## TECHNICAL SERVICE BULLETIN

SUBJECT:		No: <b>TSB- 08-21-002</b>	
<b>BUZZ OR RATTLE TYPE NOISE</b>		DATE: <b>April, 2008</b>	
		MODEL: <b>See Below</b>	
CIRCULATE TO:	<input type="checkbox"/> GENERAL MANAGER	<input checked="" type="checkbox"/> PARTS MANAGER	<input checked="" type="checkbox"/> TECHNICIAN
<input checked="" type="checkbox"/> SERVICE ADVISOR	<input checked="" type="checkbox"/> SERVICE MANAGER	<input checked="" type="checkbox"/> WARRANTY PROCESSOR	<input type="checkbox"/> SALES MANAGER

*This TSB supercedes TSB-07-21-001, issued April, 2007, to add additional model years to the Affected Vehicles. Revised information is italicized and indicated by ◀.*

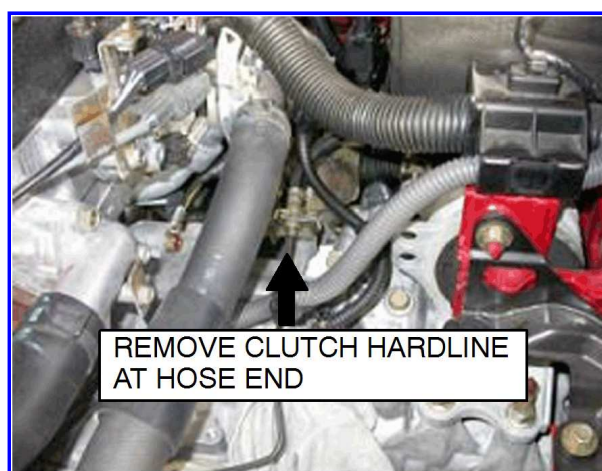
- intake duct, air cleaner box and intake tube.
4. Remove the main harness attaching clamp.

5. Remove the clutch hardline at the transmission and hose end.

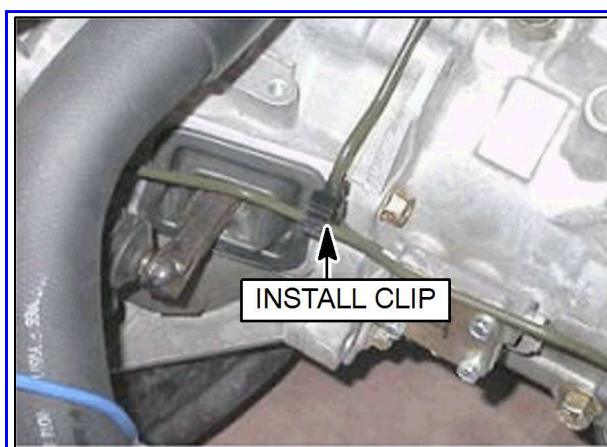
9. Torque the damper installation bolts (from Step 6) to 15-20 Nm.

10. Install the clip to separate the two new clutch lines and hold them in place.
11. Refill the clutch master cylinder with DOT 3 brake fluid and bleed the system with a helper.

Description	Part Number
Clutch Damper Kit (see photo below for kit contents)	2348A182

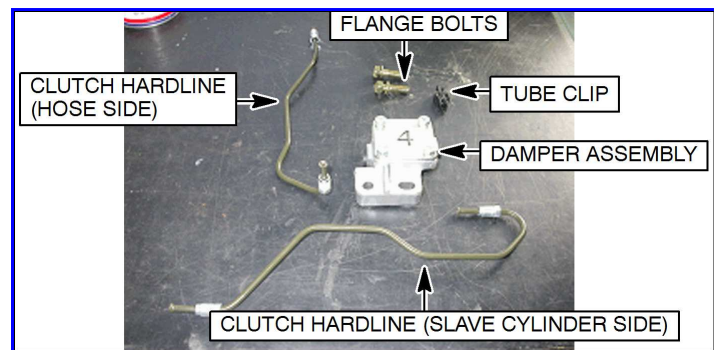
6. Install the clutch damper with the two bolts supplied in the kit. For easier line installation, hand tighten the bolts.
7. Install the new clutch hardline from the damper to the hose connection end. Fully tighten the fitting at the hose end. Tighten the fitting at the damper HAND TIGHT ONLY. See photo in the PARTS INFORMATION section of this bulletin for hardline identification.
8. Install the new clutch hardline from the slave cylinder to the damper. TIGHTEN BOTH ENDS HAND TIGHT ONLY. See photo in the PARTS INFORMATION section of this bulletin for hardline identification.
